<b>Scientific Analysis/Calculation Error Resolution Document</b> <i>Complete only applicable items.</i>	QA: QA Page 1 of 44
---	--	------------------------

1. Document Number: ANL-NBS-HS-000039	2. Revision/Addendum: REV 02	3. ERD: 02
--	---------------------------------	---------------

4. Title: Saturated Zone In-Situ Testing	5. No. of Pages Attached: 43
---	---------------------------------

**CR 12626: Editorial Corrections to DTN Numbers ANL-NBS-HS-000039 R2-Saturated Zone In-Situ Testing.**

Figure E-10. Cation-exchange Capacity Results for the Seven Different C-Wells Tuff Intervals

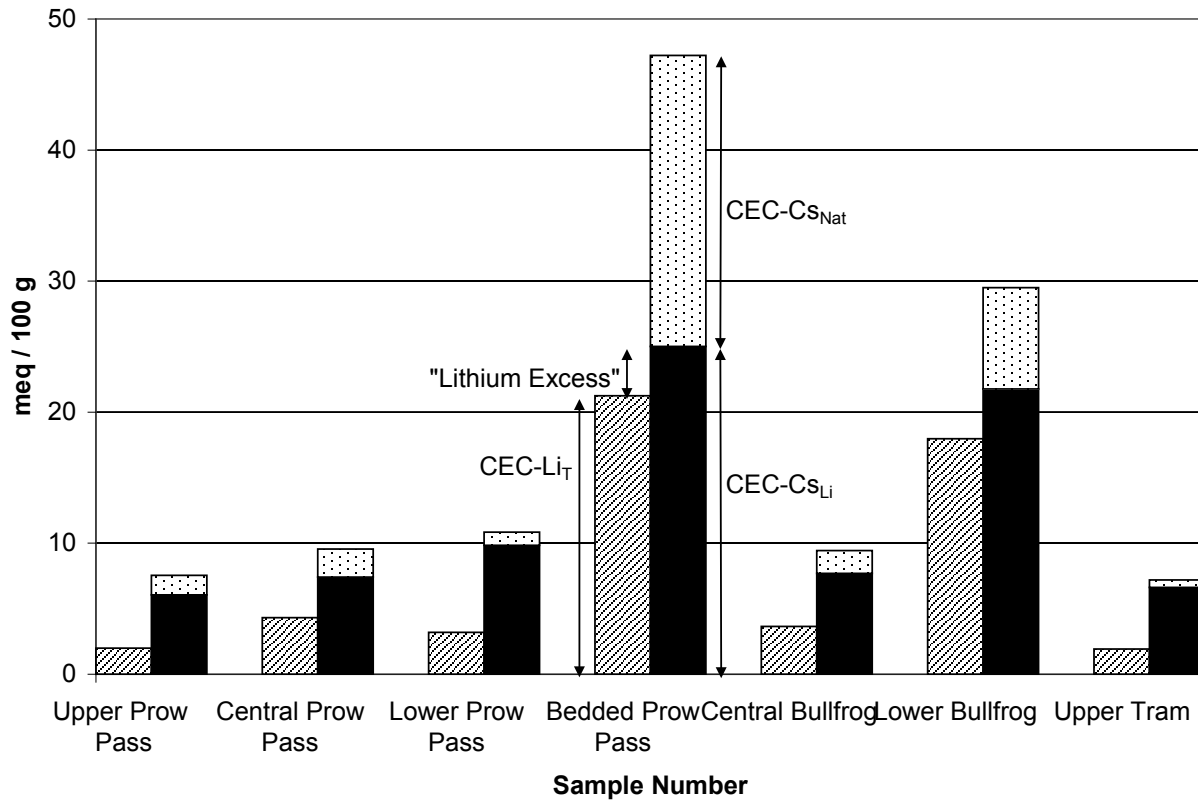
Issue identified is related to the lack of traceability between the DTN data and the data shown in Figure E-10 and Table E-5 of ANL-NBS-HS-000039 REV 02.

- Replace Figure E-10 with the figure provided below. The changes to this figure were done to incorporate the changes in Table E-5. Note that the output DTN: LA0303PR831341.001 was removed from the figure note as this DTN contains the same data as the superseded DTN: LA0302PR831341.001 [DIRS 162604].

Figure F-50. Log-saturated Hydraulic Conductivity as a Function of Depth below Land Surface in NC-EWDP-19PB.

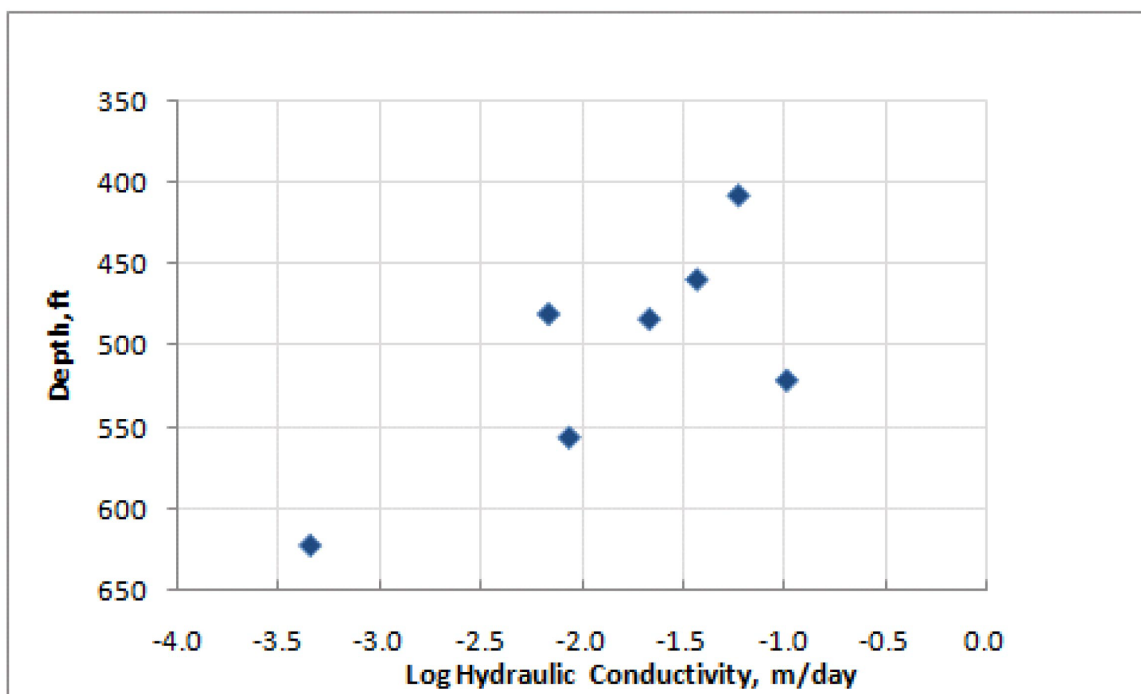
Issue identified is related to the lack of traceability between the DTN data and the data shown in Figure F-50 in ANL-NBS-HS-000039 REV 02.

To address this issue replace Figure F-50 with the following figure (Figure F-50).

Figure E-19. Bromide Diffusion Coefficients versus Tuff Permeability for All C-Wells Diffusion Cell Experiments

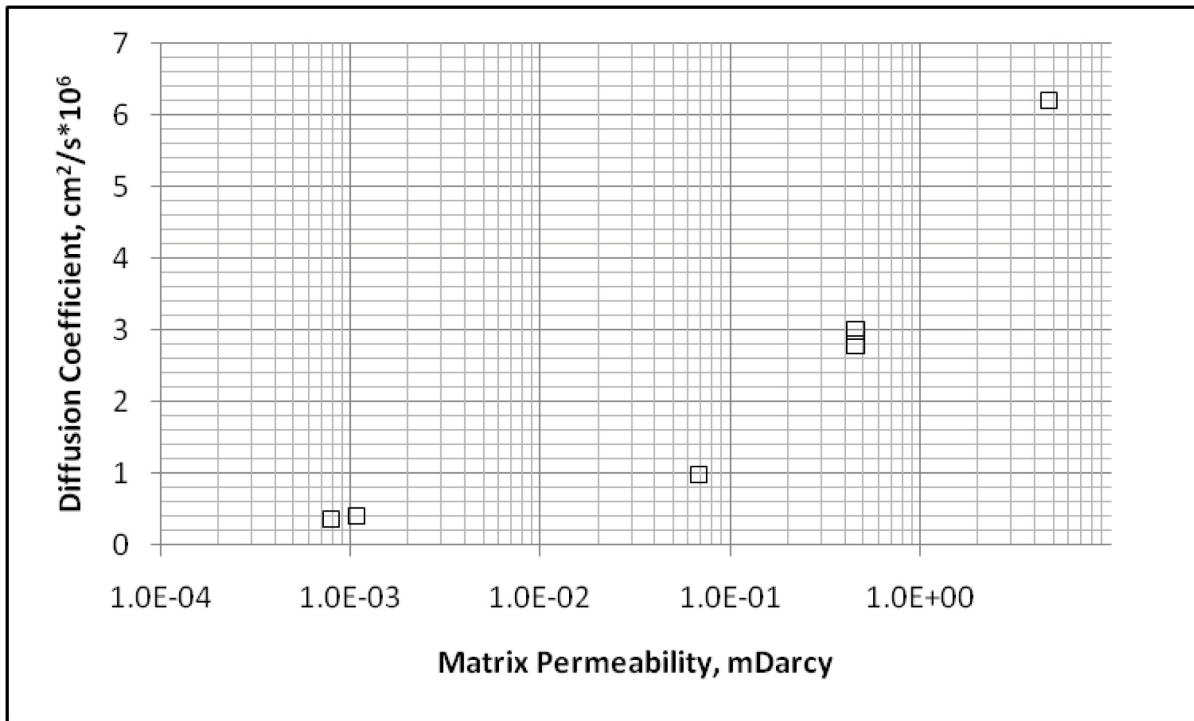
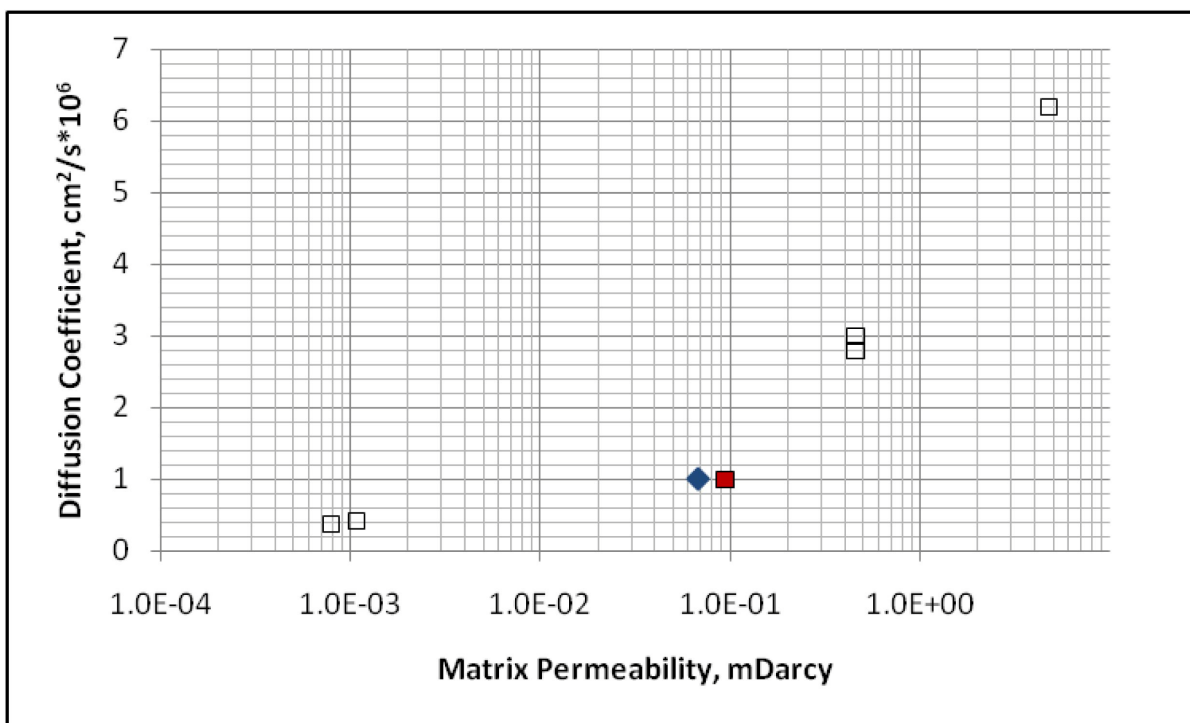
Issues identified are related to the lack of traceability between the permeability values listed in Table E-6 and data in this DTN.

DTN: MO0012PERMCHOL.000 [DIRS 153368] has two samples for the depth 1,880 ft (573 m) in well c#1. This DTN was superseded with DTN: MO0911PERMCHOL.001 [DIRS 186507] to include one missing value for this interval. The permeability of 0.455 mDarcy in Table E-6 represents the average of the 3 samples available for this depth interval.

There are two core samples (A and B) collected from the Lower Bullfrog interval in c#1 at 2,608 ft (795 m). Core sample A has three measurements of permeability and core sample B has two measurements of permeability. The value reported in Table E-6 (0.0949 mDarcy) represents an average of three samples for core A. The permeability of core sample B should be included in calculation of the average permeability of this depth interval. Consequently, the average permeability should be 0.0675 mDarcy.

- Change the permeability of the Lower Bullfrog (3) in Table E-6 (p. E-29) to 0.0675 mDarcy.
- Replace Figure E-19 (p. E-30) with the updated figure provided below.
- Add the following note to Table E-6: “NOTE: The permeability values for Lower Prow-1 and Lower Prow-2 samples represent the average of three values available for this depth interval.”

The comparison between the original and updated data in Figure E-19 is presented in the figure below to demonstrate the statement concerning no impact on the qualitative conclusion based on Figure E-19. The red data point represents the data that were originally plotted in the document and corrected in the revised plot above (blue data point).”
